DOCUMENT CHANGE REQUEST

DCR number 373	Changes required for: General	Originator: S Jeffery
Date: 2007/08/10	Date sent: 2007/08/10	Organisation: ESA/ESTEC
Status: IMPLEMENTED

Title:	Transistors High Power NPN, based on types 2N5664 through 2N5667		
Number:	5203/038	Issue:	1

ESCC Detail Specification No. 5203/038

Maximum Safe Operating Area Graph (Continuous DC) for Variants 01 to 04

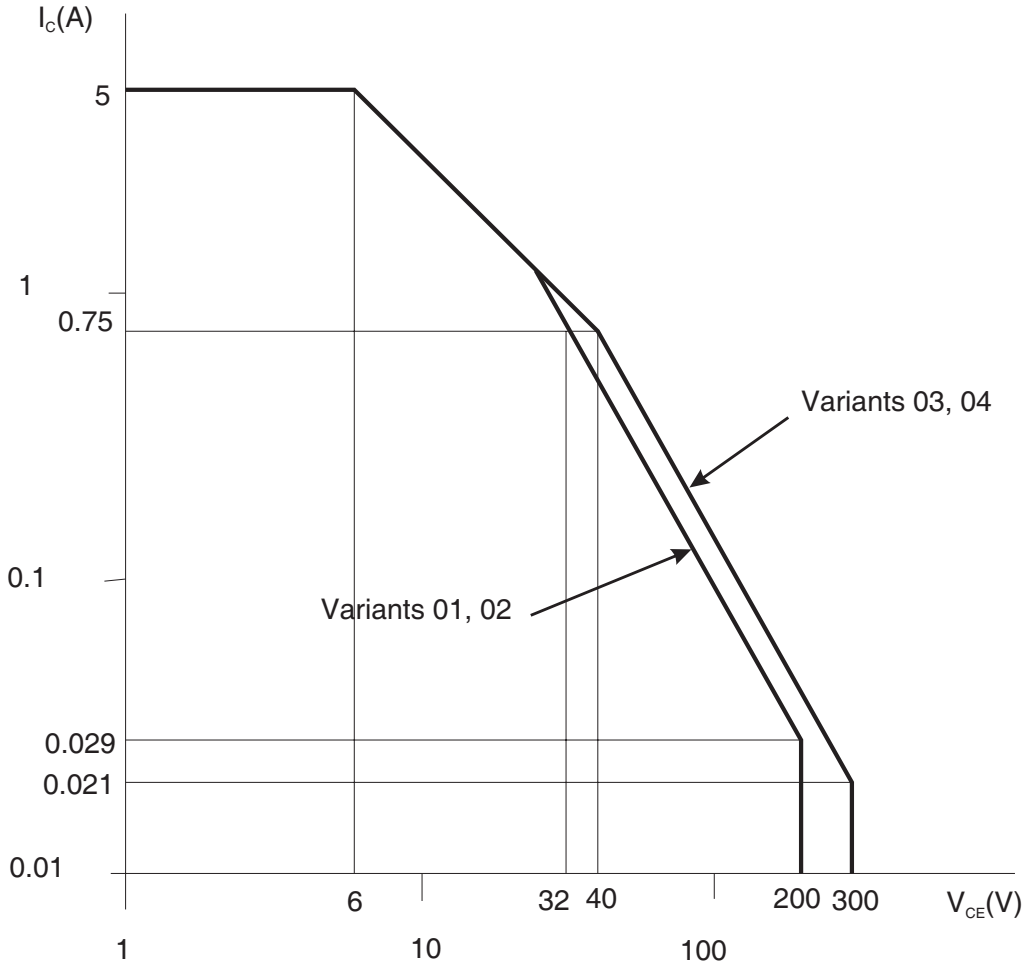
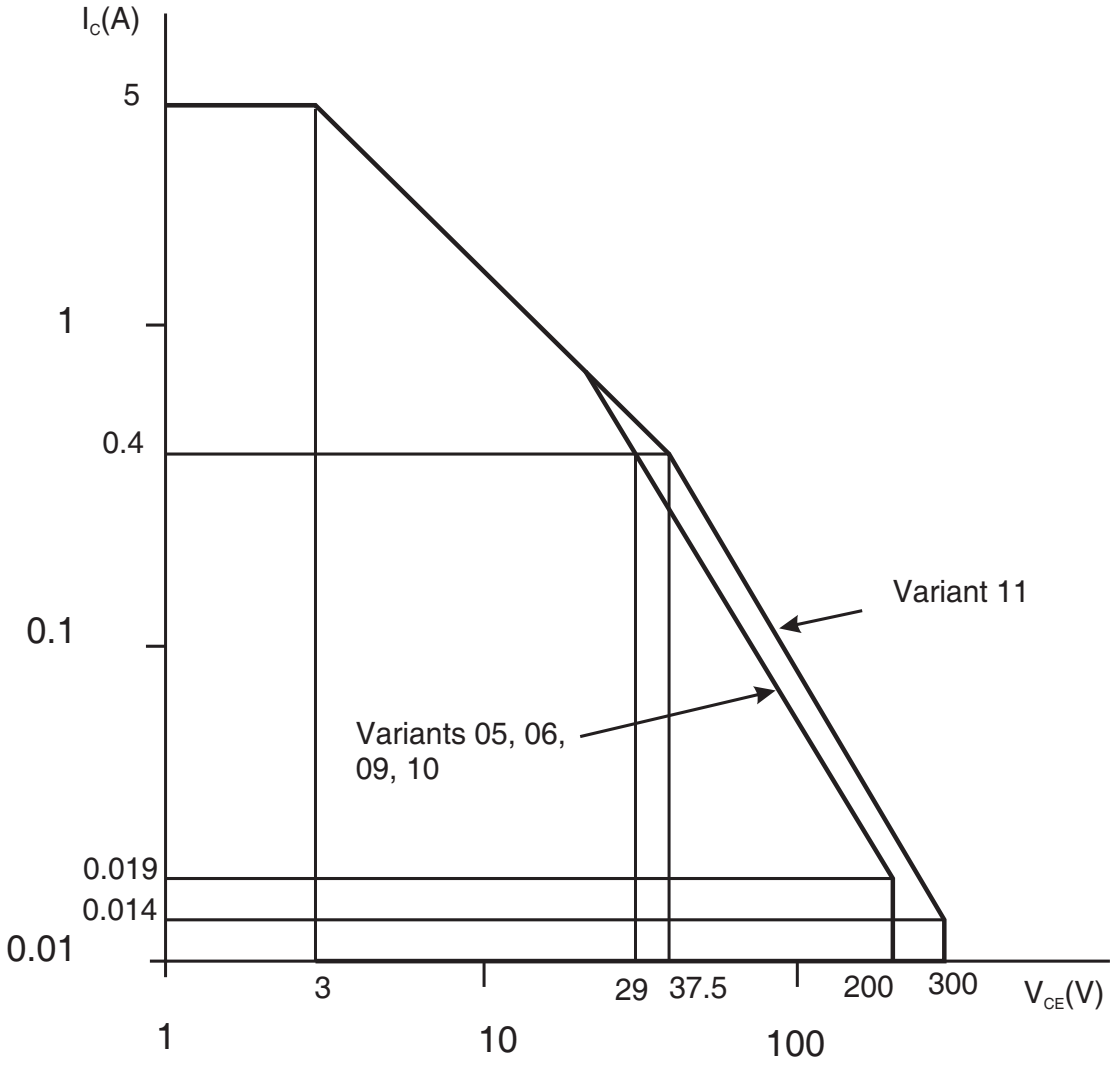
8. Figures 1(b) and 1(c), Forward Bias Safe Operating Area, amended and moved to be a note (Note 3) to the Maximum Ratings table.

1.6 PHYSICAL DIMENSIONS AND TERMINAL IDENTIFICATION

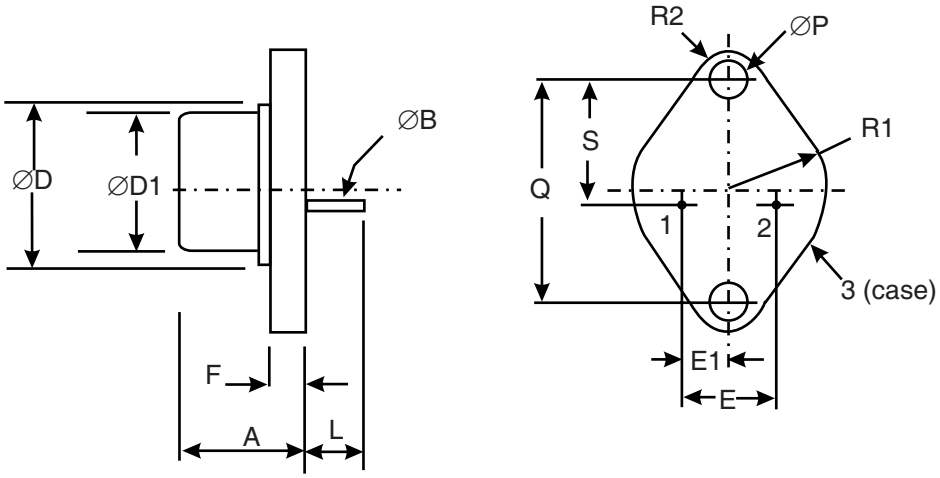
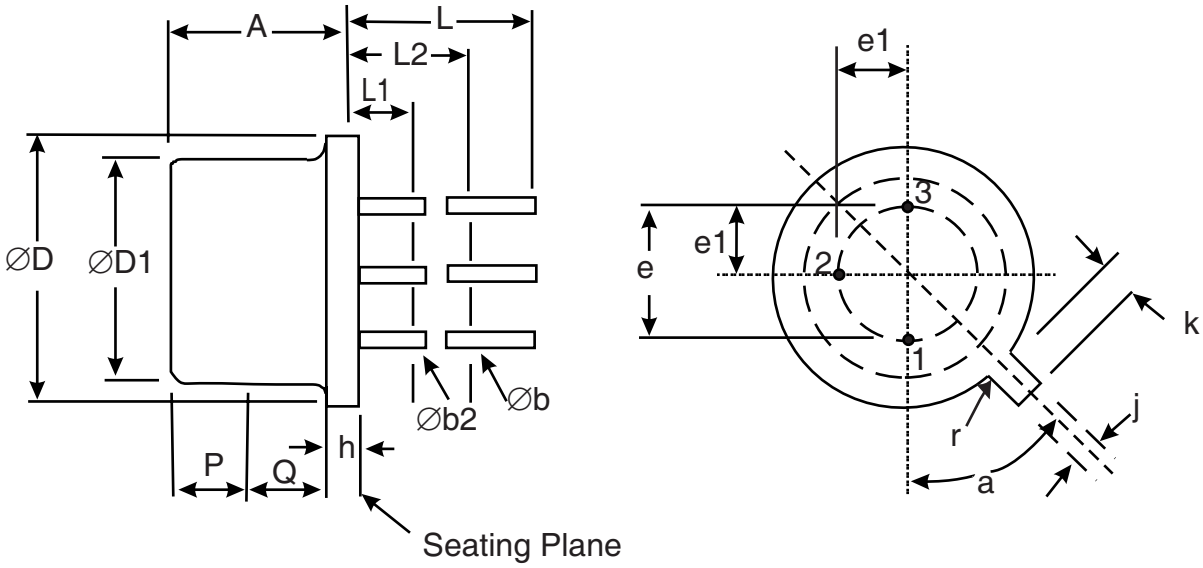
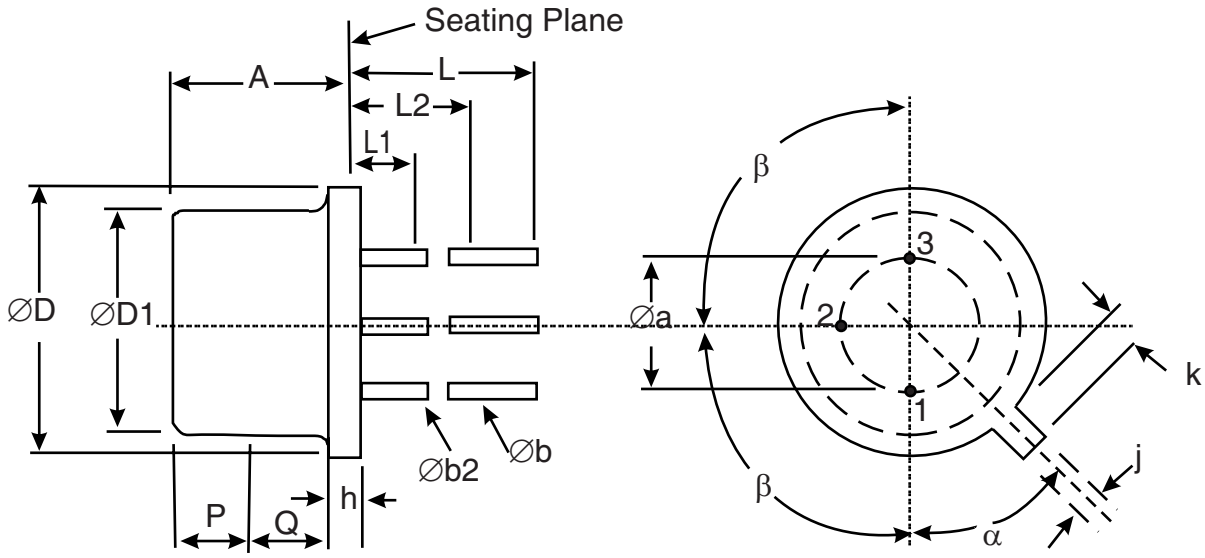
10. Figure 2 re-named "Physical Dimensions and Terminal Identification"; Figures 2(a), 2(b) and 2(c) amended (standardisation of the TO-66, TO-5 and TO-39 packages) and Consolidated Notes added.

VOLTAGE WAVEFORMS

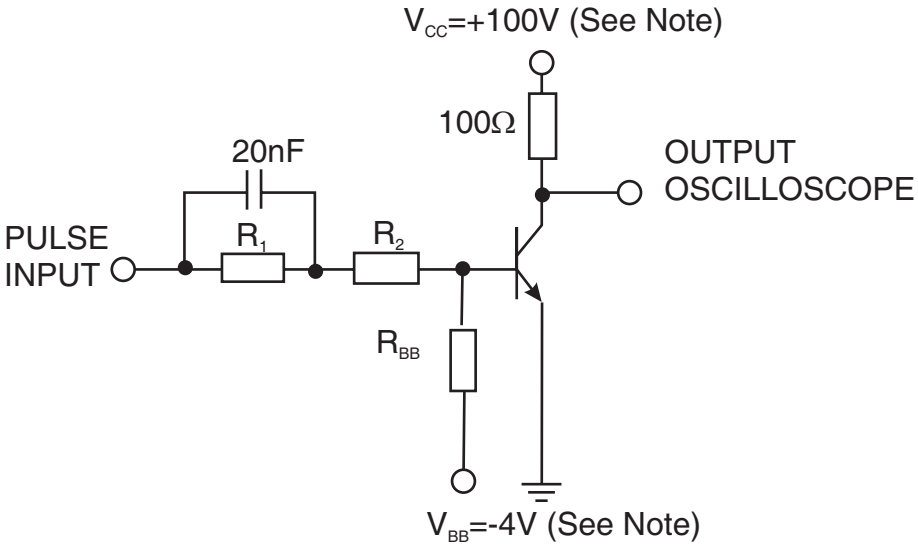
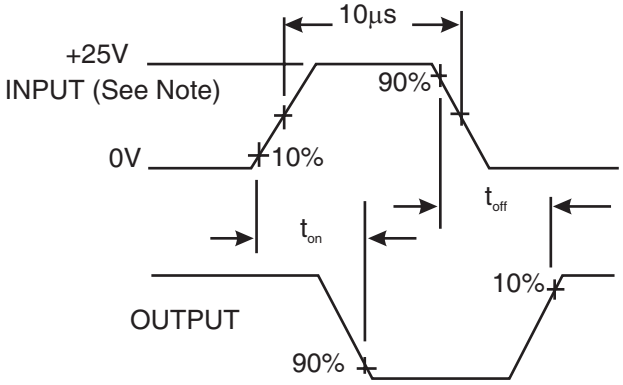
28. Figures 4(a) and 4(b) amended and combined (and Voltage Waveforms added) and moved to be a note (Note 4) to Room Temperature Electrical Measurements.
